SUNNINGDALE PARISH COUNCIL

20/02444/PT20A - 56 - 78 Beverley Court Cedar Drive Sunningdale Ascot

20/02445/PT20A - 26 - 54 Beverley Court Cedar Drive Sunningdale Ascot

The Planning Committee **STONGLY OBJECTS** to these applications.

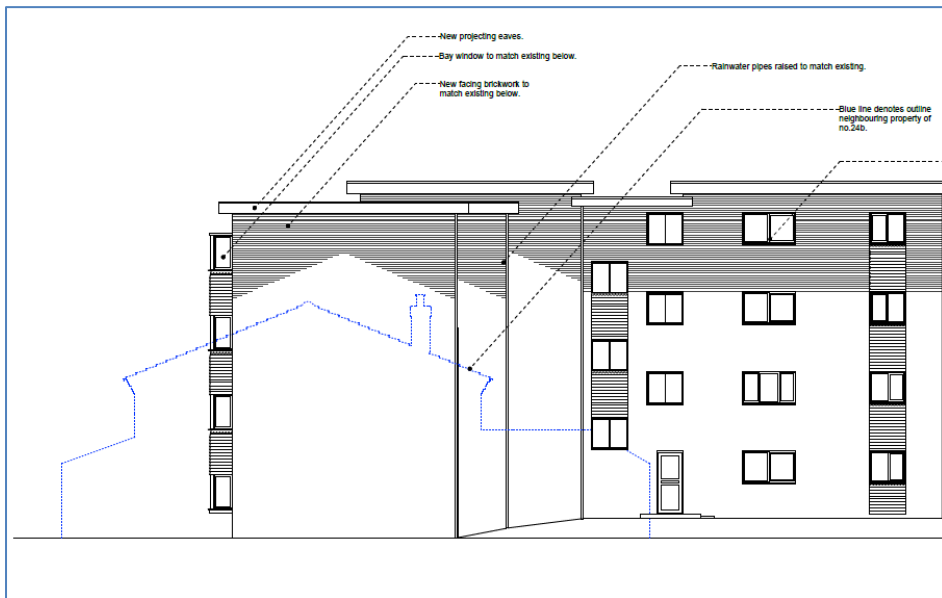
These two blocks of flats are already the tallest buildings in the road. With the additional storeys the Bulk and Scale of these two blocks would be out of character with the surrounding area and neighbouring properties (Refer - **The Ascot, Sunninghill and Sunningdale Neighbourhood Plan (NP) Policies NP/DG2**).

The additional storeys would also cause a loss of light to the adjacent neighbouring properties.

As a result of the increased height more properties in the street would be overlooked by the apartments on the 4th storey.

The contrast in adjacent roof heights is very marked. This can be seen in the eaves height of the house 24B Cedar Drive (shown below in blue outline) and the proposed Eastern elevation of the new block which is only metres away. The height of the new storey will be more than twice the height of the eaves of 24B and the garden would be cast into shade for a greater part of the day.

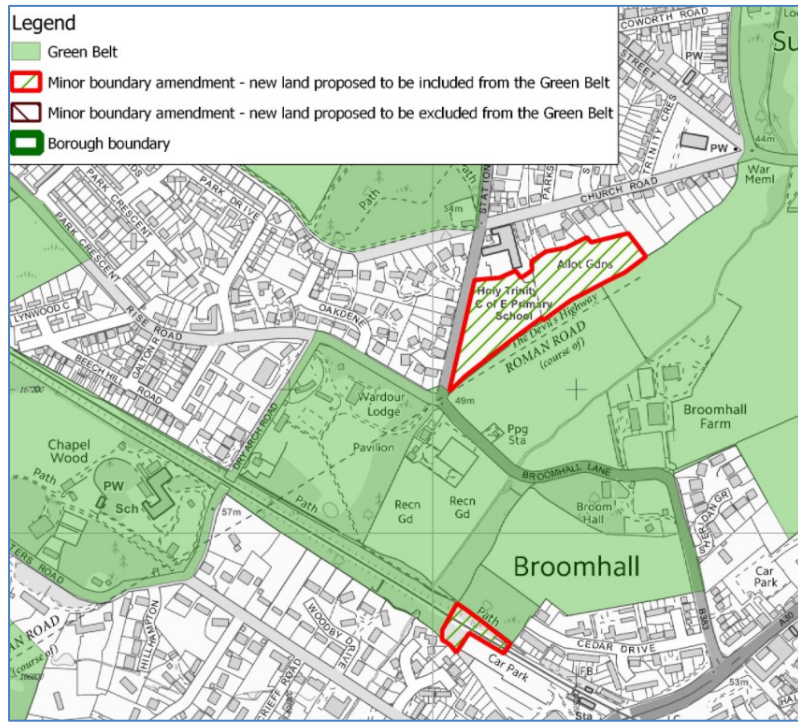
The entire area to the north of Cedar Drive is Green Belt as shown in the picture above.

With the additional storey added, both these blocks would have ridge heights which extend above surrounding trees. From the Green belt they would be quite visible and out of keeping with the ‘openness’ of the Green Belt.
